ADDENDUM

April 3, 2020

ADDENDUM # 3 Bid 20C6, Waverley Elementary School - New Construction

1 BUILDING SECTION A4.2 1/8" = 1'-0" FROM 1 / A1.1

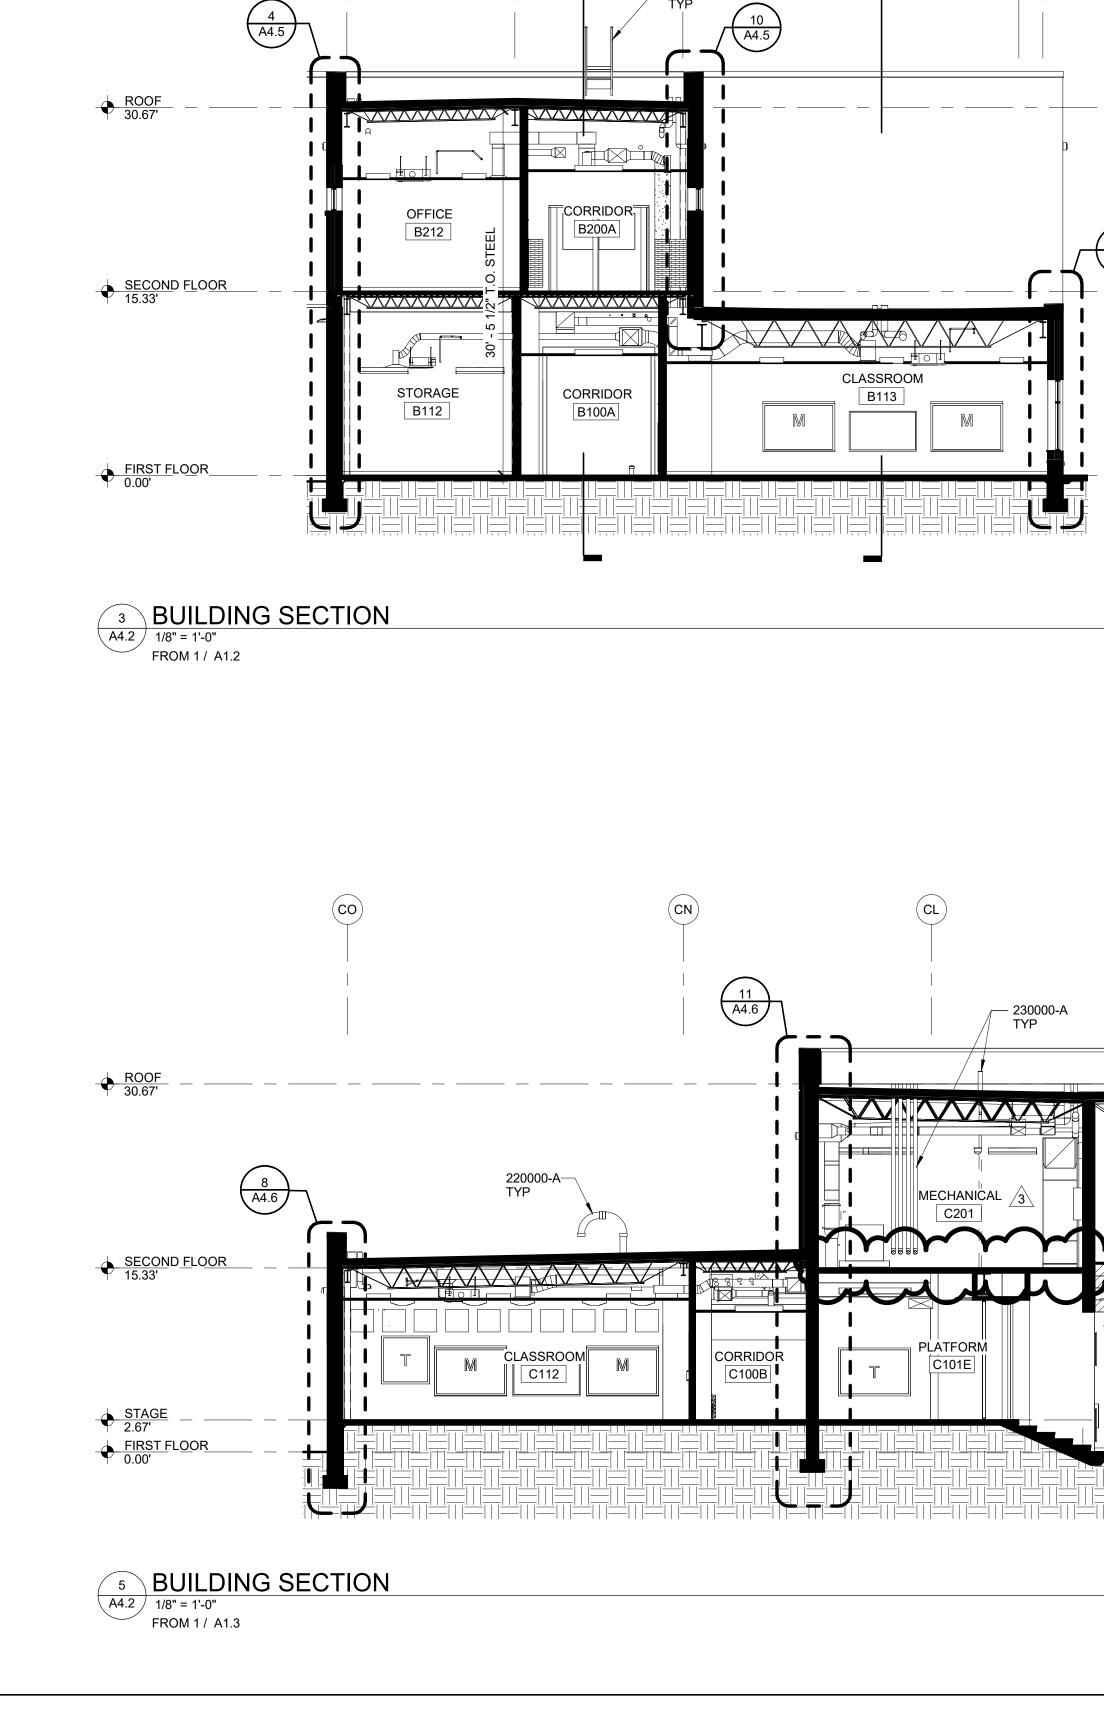
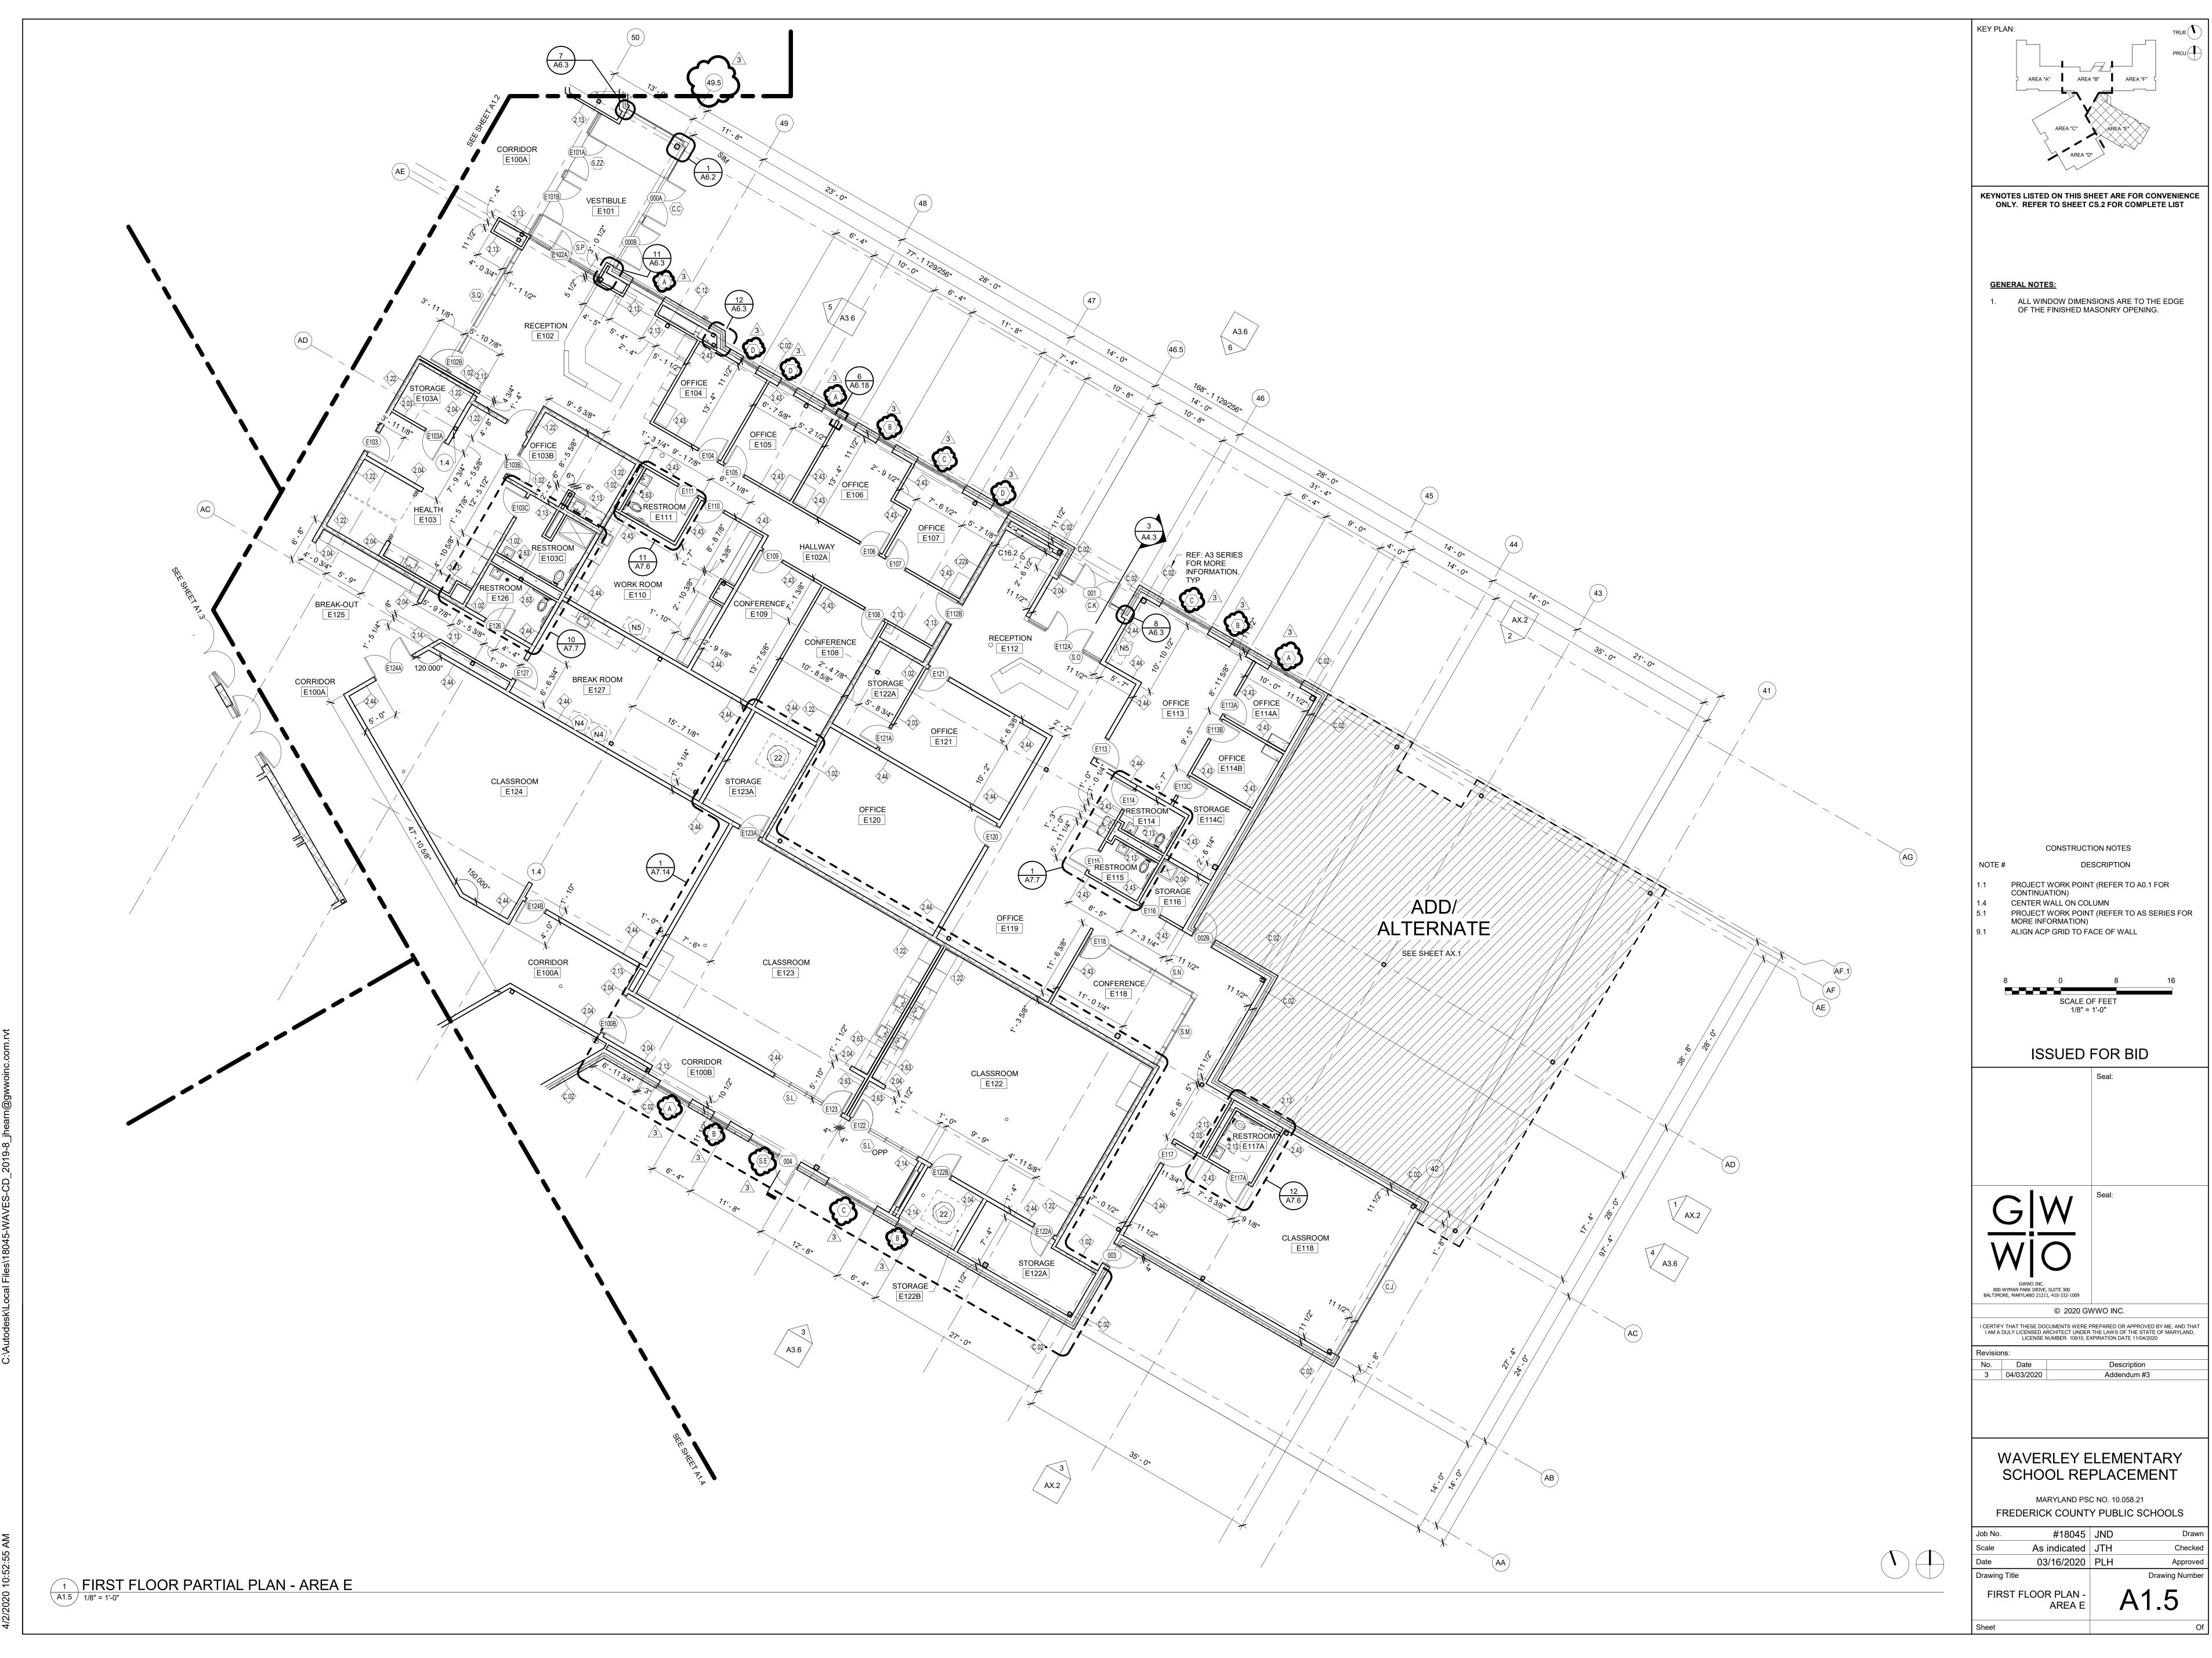
- DELETE Drawing Sheet A4.2 BUILDING SECTIONS; Issued for Bid, dated 03/06/2020; ADD Drawing Sheet A4.2 – BUILDING SECTIONS; ADDENDUM #3 (Revision dated 04/03/2020).

- ADDED Mechanical Penthouse C201 floor slab (was missing in view).
- 9. **REVISE** Drawing Sheet A4.4 WALL SECTIONS; Issued for Bid, dated 03/06/2020.

FOUNDATION PLAN - AREA A 1/8" = 1'-0"

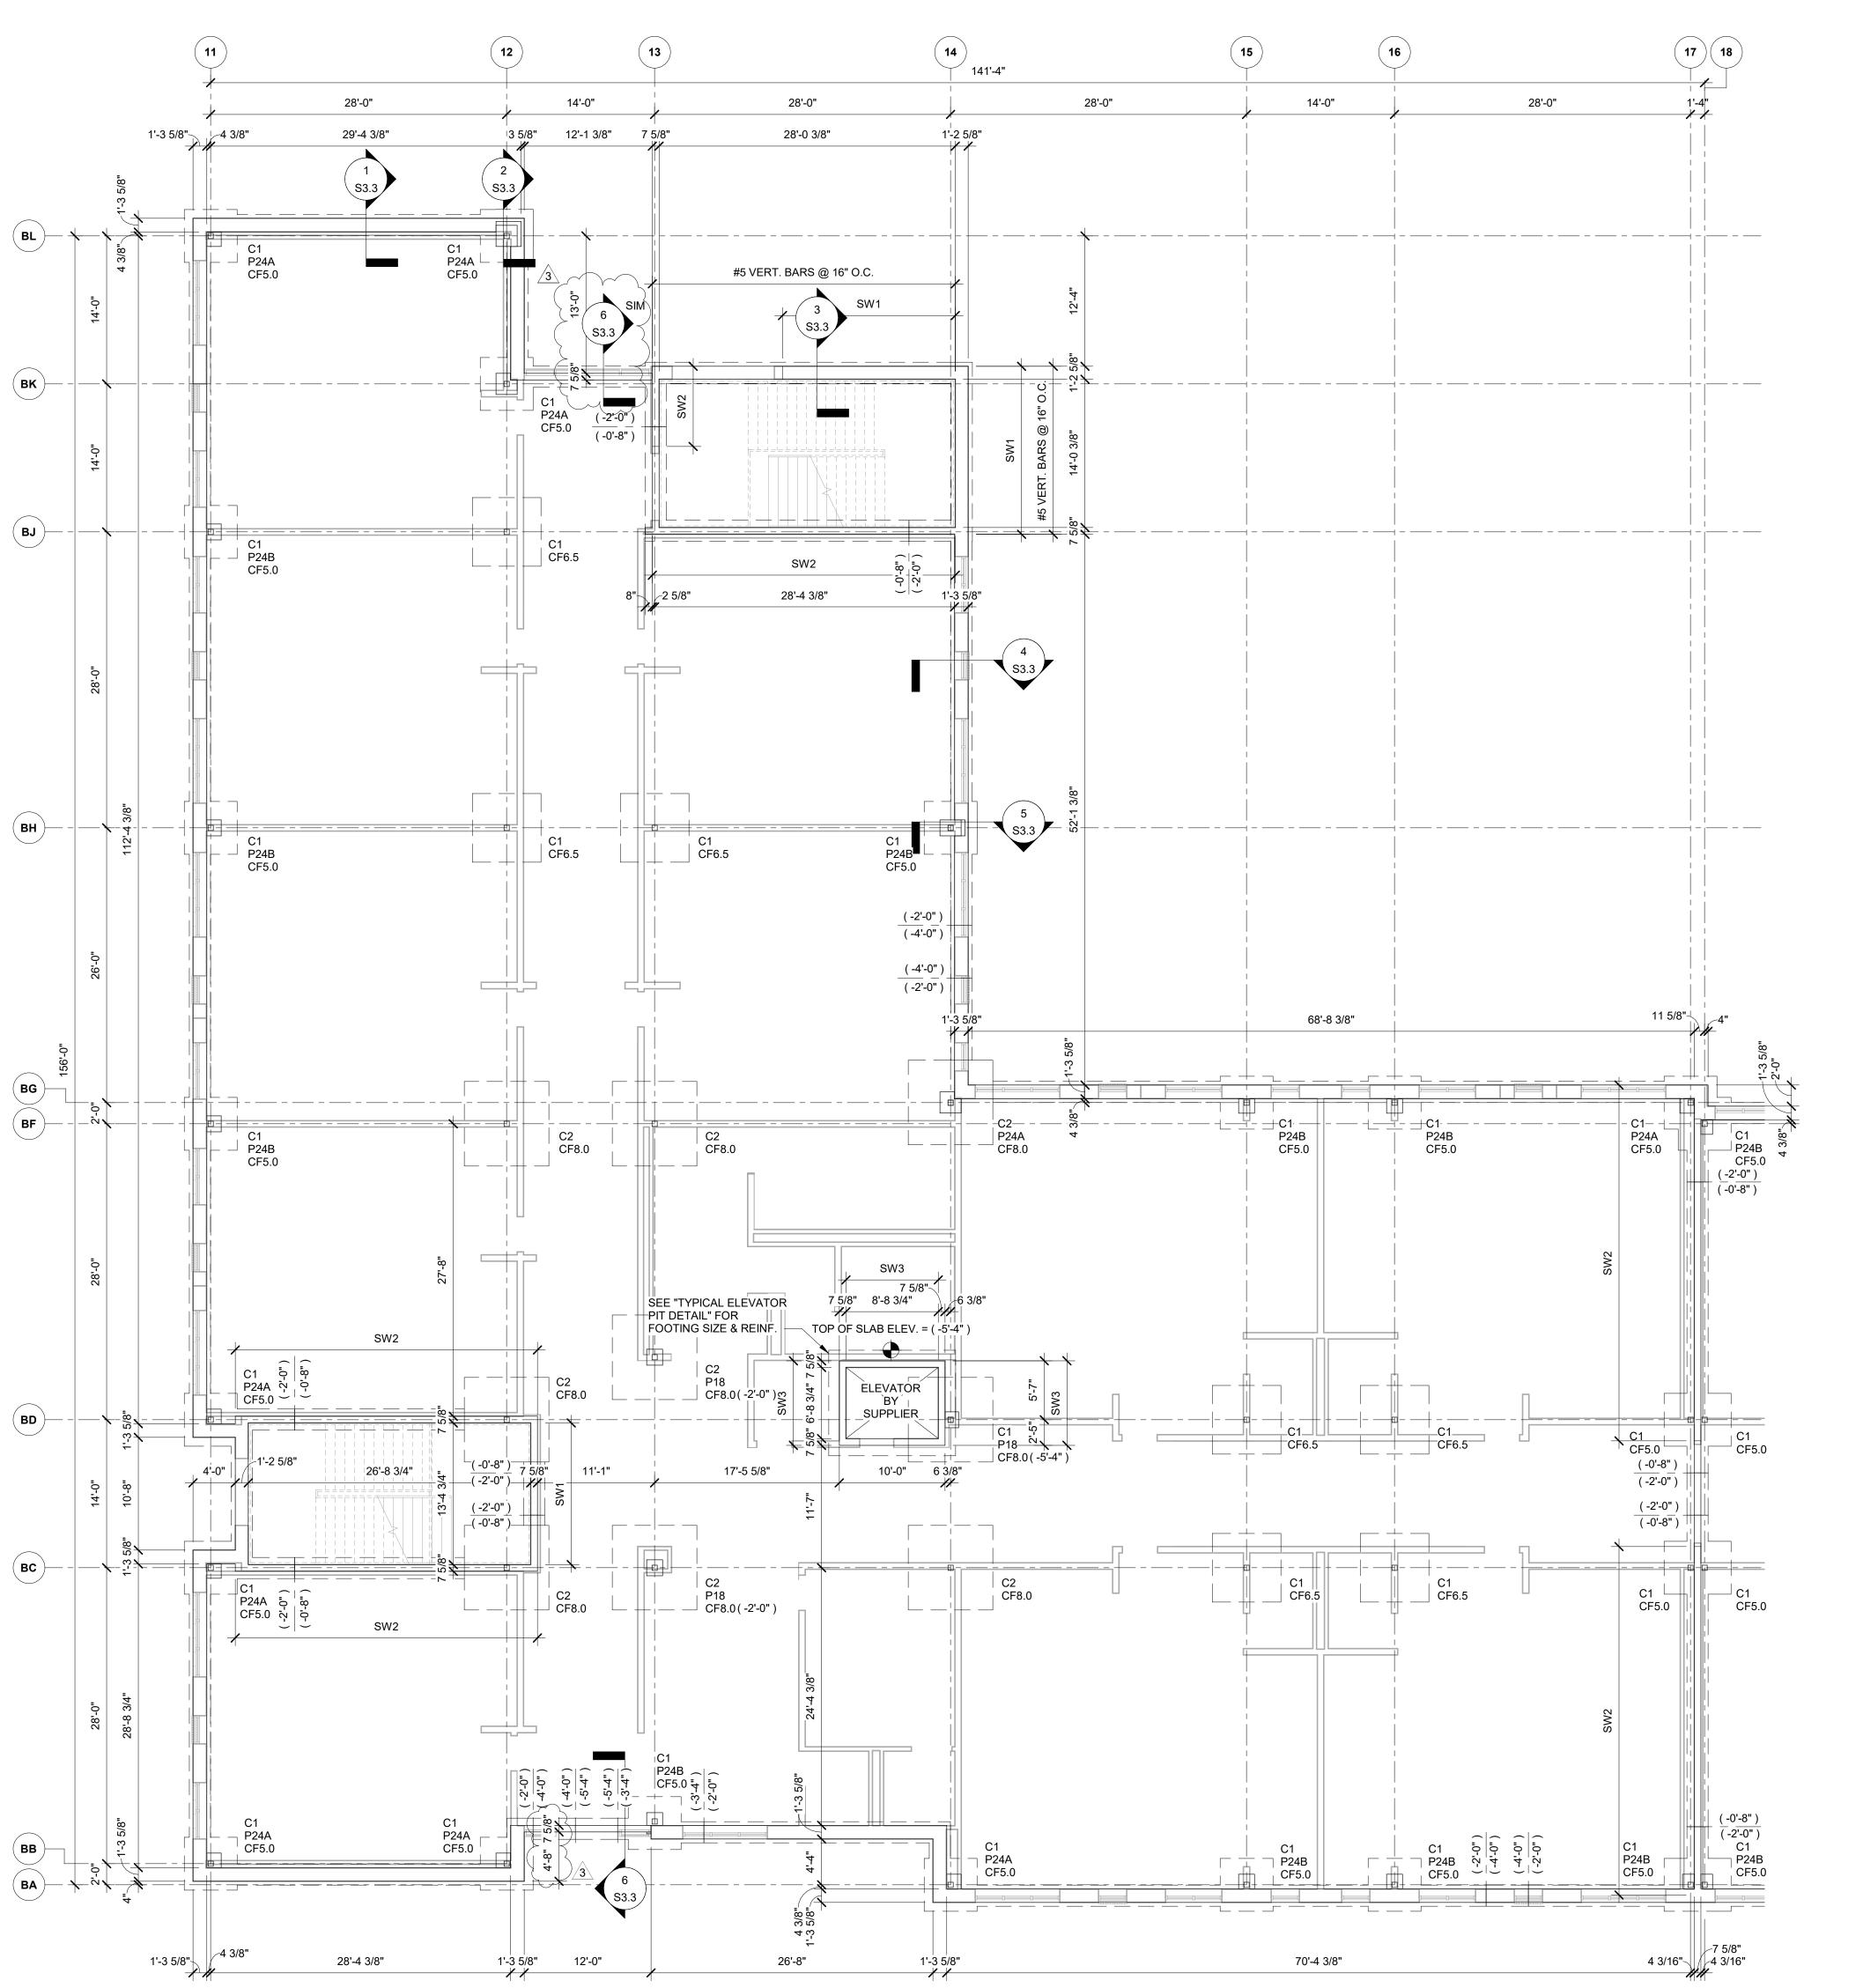
- REVISE overall length of "S.Z" is to 10'-6 3/4".
- 3.3 STRUCTURAL
 - DELETE Drawing Sheet S1.1 FOUNDATION PLAN AREA A; Issued for Bid, dated 03/06/2020. ADD Drawing Sheet S1.1 – FOUNDATION PLAN – AREA A; ADDENDUM #3 (Revision dated 04/03/2020).

- **REVISED** select foundation wall locations.
 - DELETE Drawing Sheet S1.2 FOUNDATION PLAN AREA B; Issued for Bid, dated 03/06/2020. ADD Drawing Sheet S1.2 – FOUNDATION PLAN – AREA B; ADDENDUM #3 (Revision dated 04/03/2020).
